# Detroit New Final Drive (NFD) Rear Axle Temperature Parameters

## 54-345

**Freightliner Service**  
**Bulletin**

**Fig. 11, Changing the Oil Pre-Warning Temperature Parameter Screen**

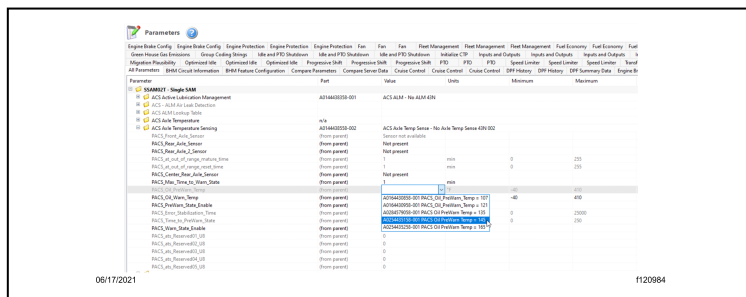
14. In the list of parameters, locate 'PACS\_Oil\_PreWarn\_Temp.' Expand the drop-down menu in the 'Value' column. Select the value, 'A0254435158-001 PACS\_OIL\_PREWARN\_TEMP = 145.' See Fig. 11 .

**Fig. 12, Changing the Oil Warning Temperature Parameter Screen**

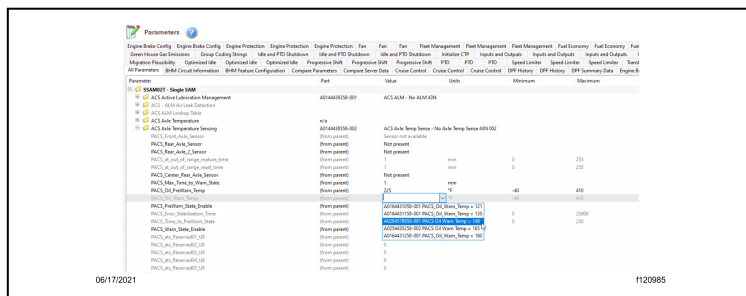
15. In the list of Parameters, locate 'PACS\_Oil\_Warn\_Temp.' Expand the drop-down menu in the 'Value' column. Select the value, 'A0284578958-001 PACS\_OIL\_WARN\_TEMP = 148.' See Fig. 12 .

**Fig. 13, Changing the Max Time to Warn Parameter**

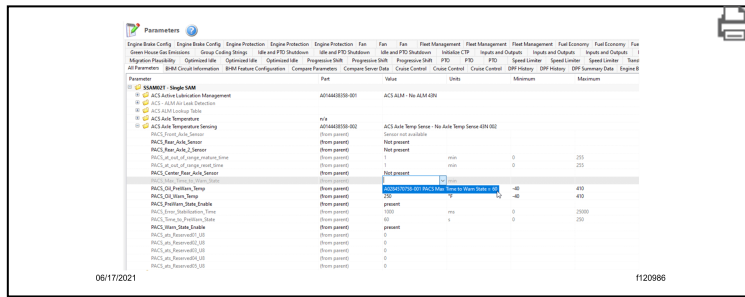
16. In the list of Parameters, locate 'PACS\_Max\_Time\_to\_Warn\_State.' Expand the dropdown in the Value column. Select the value, 'A0284570758-001 PACS\_MAX\_TIME\_TO\_WARN\_STATE = 60.' See Fig. 13 .
